P96-119 HERITAGE PLACE PUD SUBDIVISION

- REQUEST:** A. Environmental Determination: Prior Negative Declaration
- B. Plan Review of gate and wall design for a gated subdivision in the proposed R-1A{PUD} zone.

SUMMARY/RECOMMENDATION:

EXHIBIT A -- CONCEPTUAL ENTRY DESIGN

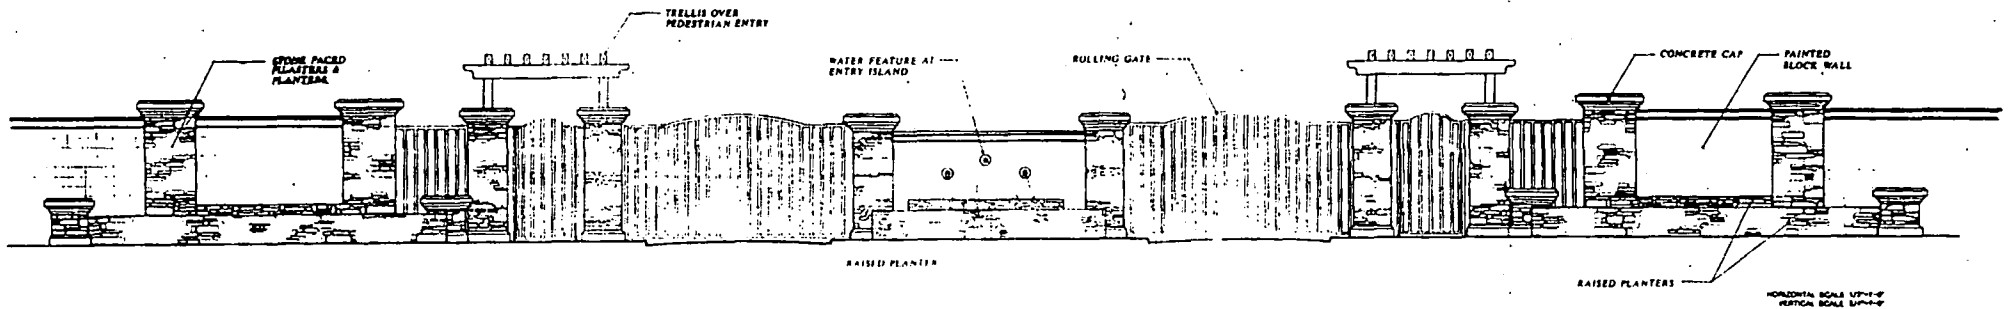
The applicant proposes to provide a concrete block wall painted buff/light tan. Landscaping will be planted on the street side of the wall. The gates will consist of tubular steel, painted dark green. Pilasters (structural piers to anchor the wall) will be used as decorative columns to provide additional relief. The pilasters and planters will consist of decorative stoneface, and decorative concrete caps will be mounted atop the pilasters. The water feature is proposed as a concrete block wall with cast concrete spouts pouring into a lined concrete and concrete block basin with the equipment behind the wall. Wood trellises (painted dark green) will be placed arching over each of the pedestrian entry gates. Overall, staff feels that this is a high quality design treatment that is worthy of approval. However, staff recommends that the wood trellises not be painted, but should be stained (similar to the treatment of trellises in the REI building on Expo Parkway). Also, staff recommends that the block wall should be finished with a smooth stucco coat prior to painting.

The vehicle entry/exit gates are "slide gates" designed to allow both gates to open independently or simultaneously. (The gates open into an overlap position within the median.) The gates open/close at the speed of one foot per second. The applicant feels that the slide gates are more reliable than the swing gates, in that impatient motorists often bump the swing gates. Also, the swing gates require more rigid anchoring to support the full weight of the gates, whereas the slide gates are supported along a track. The gates are also required to be equipped with a Knox lock that opens both gates simultaneously. In the event of a power failure, the gates can be opened and closed manually.

1. City Public Works-Engineering Development Services: Public Works requires adequate turning radius between the islands to allow for a U-Turn, and the gate controller shall be set back at least 15' from Gateway Oaks Drive.

2. The walls and gates shall be constructed in substantial conformance to the drawings attached as Exhibit A.
3. The width of each of the two vehicle entry gates shall be a minimum of fourteen feet (14').
4. The Knox switch must activate both entry gates simultaneously.
5. No anti-directional devices may be installed at the gated entries.
6. The gate controller shall be setback at least 15' from Gateway Oaks Drive.
7. ~~The trellis shall be stained wood, rather than painted.~~ {deleted by Commission}. *The trellis shown on the attached Exhibit A shall be deleted.* {added by Commission}
8. The block wall shall be finished with a smooth stucco or painted surface in order to minimize the appearance of grout lines.
9. *Stone pilasters shall be added, to the satisfaction of staff, at regular intervals along the outside wall elevation along Gateway Oaks Drive.* {added by Commission}
